# UNITED STATES PATENT AND TRADEMARK OFFICE

APPLICATION NO.	FILING DATE	FIRST NAMED INVENTOR	ATTORNEY DOCKET NO.	CONFIRMATION NO.
09/960,712	09/21/2001	Stan J. Simpson	08998-00693	4279
37705	7590	07/06/2006	EXAMINER KUMAR, RAKESH	
GREENBERG TRAURIG, LLP 1200 SEVENTEENTH STREET, SUITE 2400 DENVER, CO 80202			ART UNIT 3654	PAPER NUMBER

### **Final Rejection**

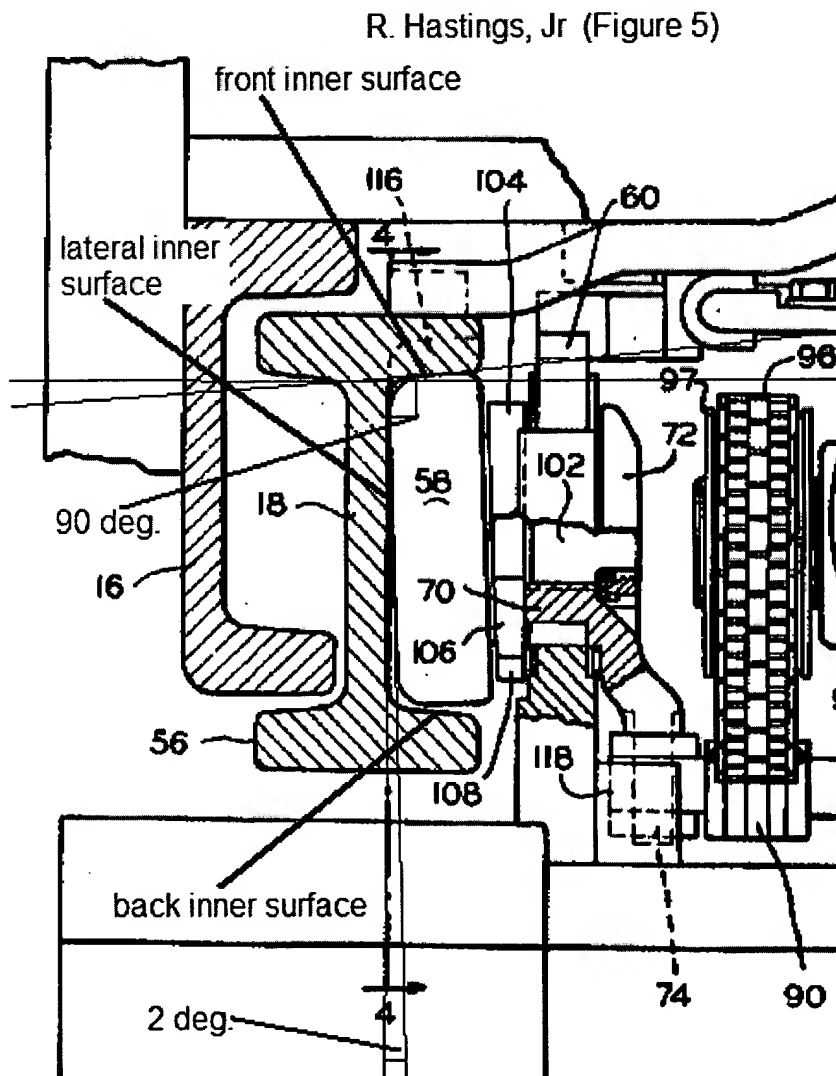
Hasting '853 discloses a mast for forklift truck comprising a carriage assembly 50, Fig. 2, having a first upper roller 64, a first lower roller 58, a second upper roller 64, and a second lower roller 58 and a front surface, and a first rail section, Fig. 5 including a first rail 18 and a second rail 18 positioned substantially parallel to each other, each rail 18 having a back inner surface (right hand portion in Figs 59) being substantially parallel to the front surface, a front inner surface (116) and a lateral inner surface (middle portion) adjacent to

the front inner surface and the lateral inner surface is substantially normal to the front surface, wherein each of the front inner surface and the lateral inner surface of respective first and second rails is about  $92^\circ$ .

Re claim 34, Fig. 5. shows a first rail comprises a first inner surface including a first back inner surface, a first front inner surface substantially opposite the first back inner surface, a first lateral inner surface that connects the first back inner surface and the first front inner surface; a second rail positioned substantially parallel to the first rail, where the second rail comprises a second inner surface including a second back inner surface, a second front inner surface substantially opposite the second back inner surface, and a second lateral inner surface that connects the second back inner surface and the second front inner surface; Figure 2 shows a carriage assembly comprising a first upper roller, a second upper roller positioned substantially opposite the first upper roller, a first lower roller, a second lower roller positioned substantially opposite the first lower roller, and a front surface; wherein the first upper roller and the first lower roller of the carriage assembly are operatively guided by the first inner surface of the first rail, and the second upper roller and the second lower roller of the carriage assembly are operatively guided by the second inner surface of the second rail, to cause the front surface of the carriage assembly to move along at least a portion of the length the first rail and the second rail; wherein the first lateral inner surface has a first front portion adjacent to first front inner surface and the second lateral inner surface has a second front portion adjacent to the second front inner surface, wherein the first front portion and the second front portion are substantially normal to the front surface; wherein the

intersection of the first front inner surface and the first front portion forms a first angle (see Figures 5-9) between the first front inner surface and the first front portion; wherein the first angle is greater than or equal to 90.5 degrees.

JP "092 (Figure 6)

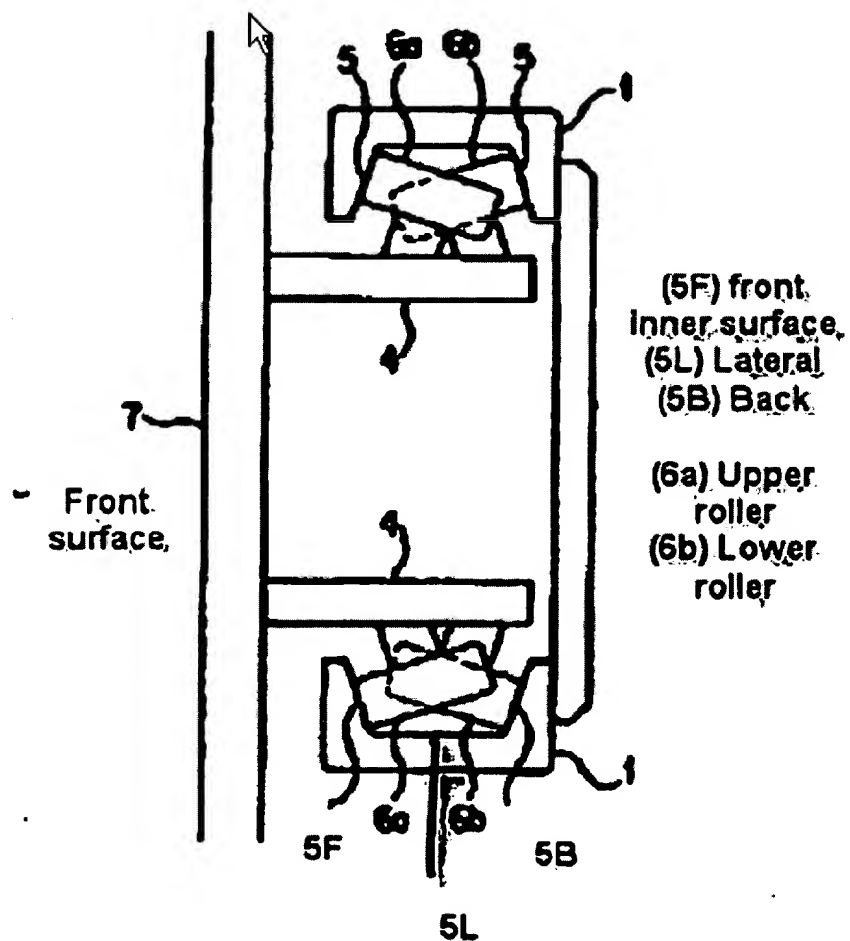
JP'092 discloses a mast for forklift truck comprising a first rail (Figure 6) comprises a first inner surface including a first back inner surface, a first front inner surface substantially opposite the first back inner surface, a first lateral inner surface that connects the first back inner surface and the first front inner surface; a second rail positioned substantially parallel to the first rail, where the second rail comprises a second inner surface including a second back inner surface, a second front inner surface substantially opposite the second back inner surface, and a second lateral inner surface that connects the second back inner surface and the second front inner surface; a carriage assembly comprising a first upper roller, a second upper roller positioned substantially opposite the first upper roller, a first lower roller, a second lower roller positioned substantially opposite the first lower roller, and a front surface; wherein the first upper roller and the first lower roller of the carriage assembly are operatively guided by the first inner surface of the first rail, and the second upper roller and the second lower roller of the carriage assembly are operatively guided by the second inner surface of the second rail, to cause the front surface of the carriage assembly to move along at least a portion of the length the first rail and the second rail; wherein the first lateral inner surface has a first front portion adjacent to first front inner surface and the second lateral inner surface has a second front portion adjacent to the second front inner surface, wherein

the first front portion and the second front portion are substantially normal to the front surface; wherein the intersection of the first front inner surface and the first front portion forms a first angle (see Figures 5-9) between the first front inner surface and the first front portion; wherein the first angle is greater than or equal to 90.5 degrees.
